# Mega Dyeing Ltd.

Shardagonj, Gabindabari, Joydevpur, Gazipur, Dhaka  
(+23.965735N, 90.285605E)

13 & 26 April 2014

# Observations

# Building 2 - High stress in columns

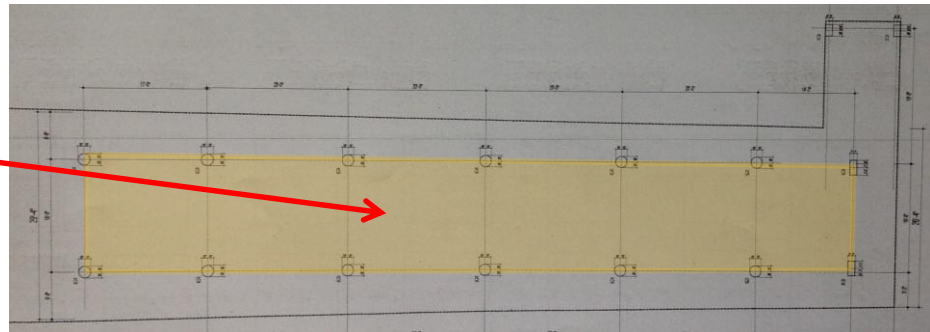
Storage loading within Building 2 on upper floors. Estimated loading in areas up to 4.9kPa. Cursory calculations indicate that column stresses are fairly high.

Large water tank on roof of Building 2 (currently empty). Factory management indicate no intention to fill this tank. Tank should remain empty until checks completed.

12	Building 2 - High stress in columns	Produce and actively manage a loading plan for all floor plates within the factory giving consideration to floor capacity and column capacity.	6-months
13	Inadequacy of steel stairs around and within buildings	All steel stair structures within the complex to be reviewed and assessed for adequacy by Building Engineers. Strength, stability and detailing of connections to other structures to be considered.	6-weeks
14	Inadequacy of steel stairs around and within buildings	A fire evacuation scenario to be used to determine loading requirements on all stairs.	6-weeks
15	Inadequacy of steel stairs around and within buildings	Strengthening works to steel stair structures as required by Building Engineer assessment to be completed.	6-months

**Escape stairs to Building 2**

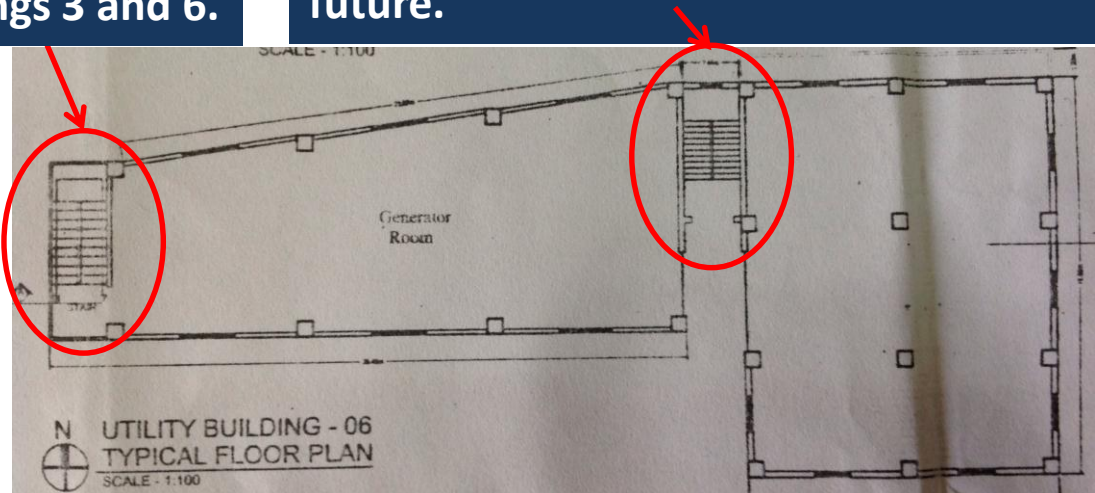
**Numerous steel stairs around and within buildings which appear to be non-engineered.**

**Access to mezzanine level within Building 5**

**Steel escape stairs provided between Buildings 3 and 6.**

**Stairs within Building 6 not constructed. Factory management indicate this will be constructed in future.**

Steel stairs around and within buildings

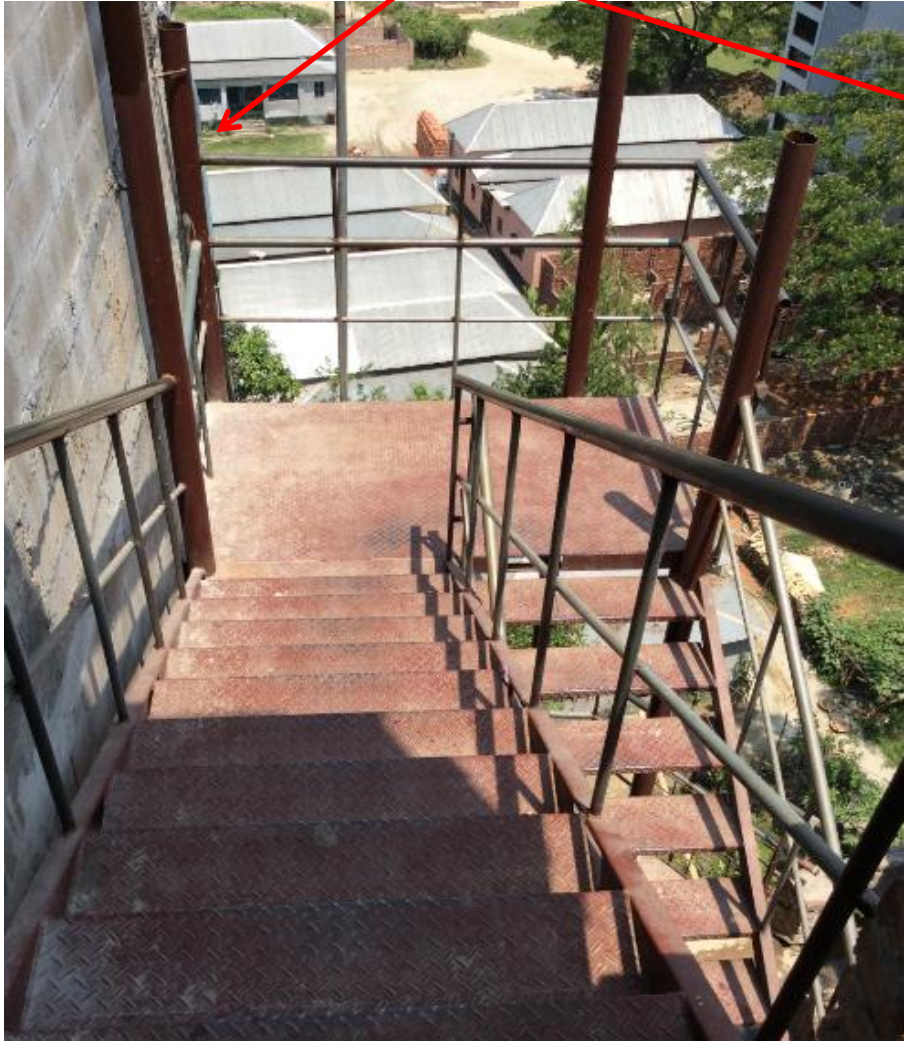
Some evidence of minor corrosion to steelwork. Water flowing down stairs between Building 3 and Building 6.

Stairs have limited independent lateral stability systems and poor connections to neighbouring buildings.

Fire escape stairs adjacent to Building 3 has no apparent lateral stability system and is not tied into the Building 3 structure.

Water tank above Crèche

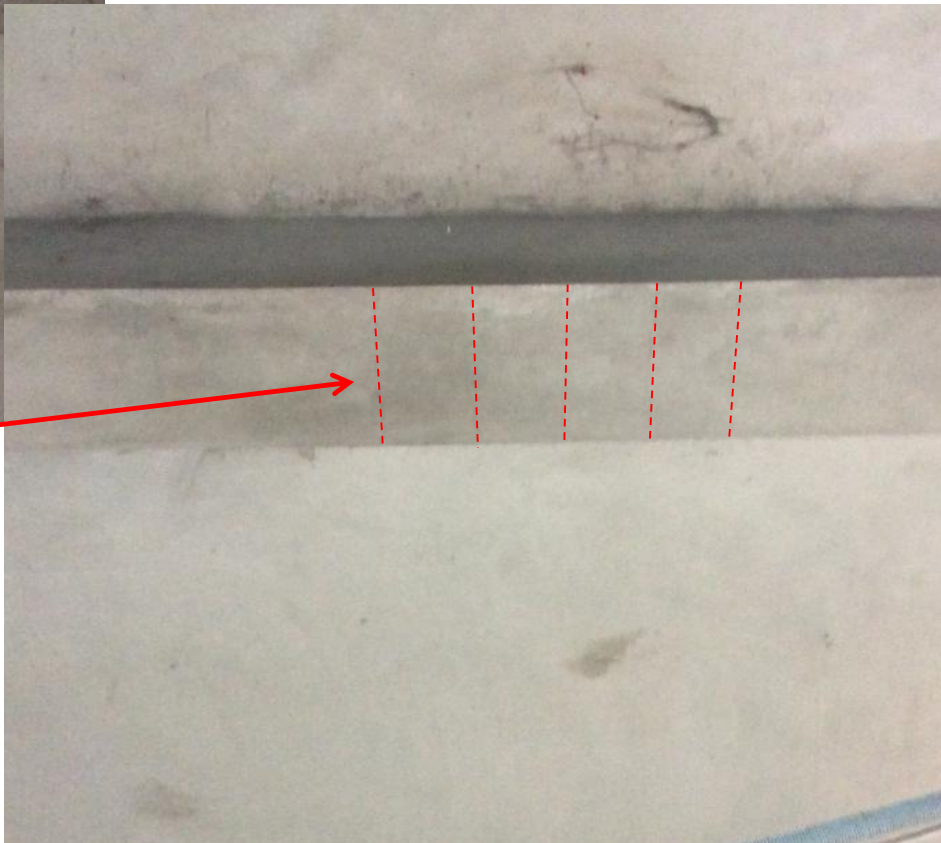
Areas of dampness observed on walls and ceiling of Crèche/Doctor's Room. Solid concrete water tank located directly above.

Structural cracking observed in beam in Doctor's Room.

Structural cracking observed in column in Crèche/Doctor's Room.

Item No.	Observation	Recommended Action Plan	Recommended Timeline
16	Structural cracking in Doctor's Room and Crèche	Empty water tank above and do not use until Building Engineer has reviewed the building and any strengthening works are complete.	6-weeks
17	Structural cracking in Doctor's Room and Crèche	Building Engineer to identify all cases of cracking and distress of structural elements in the Doctor's Room and Crèche. Strength and integrity of existing structural elements to be assessed.	6-weeks
18	Structural cracking in Doctor's Room and Crèche	Strengthening works and crack repairs to be implemented, as necessary, to Building Engineer's details.	6-weeks
19	Structural cracking in Doctor's Room and Crèche	Strengthening works and crack repairs to be completed.	6-months
20	Structural cracking in Doctor's Room and Crèche	Continue to monitor cracking and signs of element distress in this area.	6-months

## **Cracking in Beams**

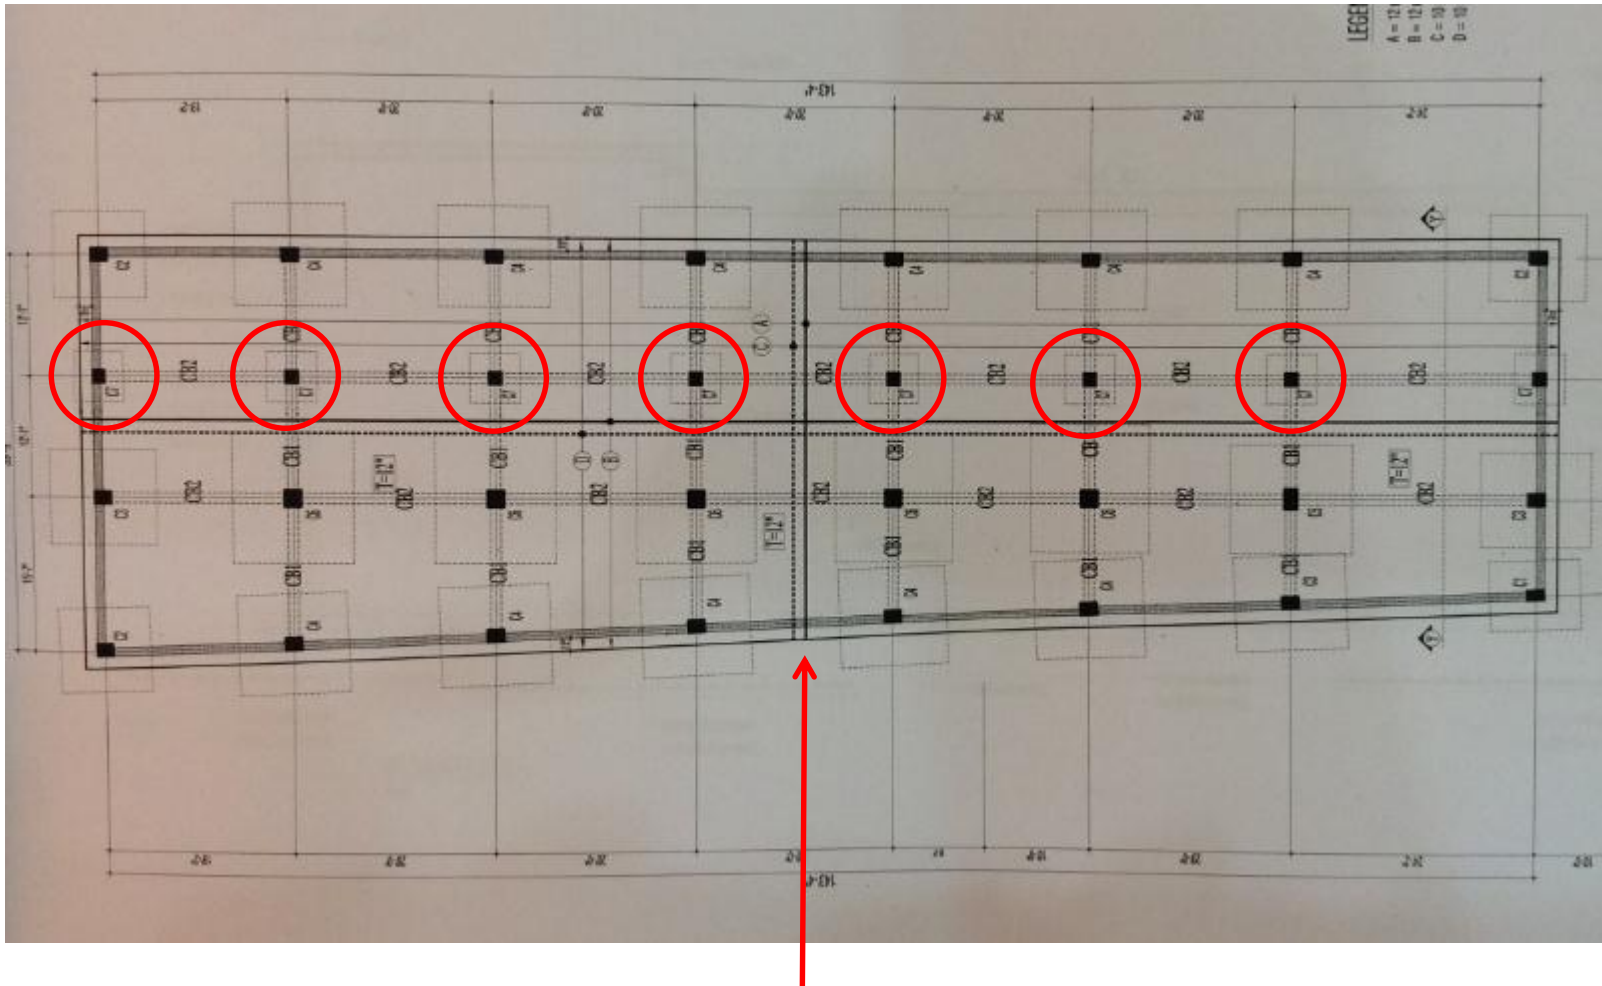
**Cracking at mid-span in beams in Building 4 at underside of 1<sup>st</sup> floor. Building Engineer to investigate cause of cracks and to inspect if cracks go through plaster to the structure.**

21	Building 4 - Cracking of beams on the underside of 1st floor	Monitor cracks in beams. Conduct regular inspection of cracks. Investigate if cracks are only in the plastering.	6-months
22	Building 4 - Cracking of beams on the underside of 1st floor	If cracks grow larger, remove all items above the beams and close working areas below the affected areas. Engage an engineer to investigate, repair and strengthen the beam.	6-months
23	Building Engineer to inspect the columns under the ground floor of Building 3 once the reservoir has been drained.	Reservoir to be drained to undertake annual inspections to satisfy the Building Engineer that corrosion is not occurring. After this time, if no corrosion is present, inspections to be at a less frequent period of 3-5 years.	6-months
24	Building Engineer to inspect the columns under the ground floor of Building 3 once the reservoir has been drained.	Due attention to safety of inspection when undertaking assessment of reservoir columns in confined space.	6-months
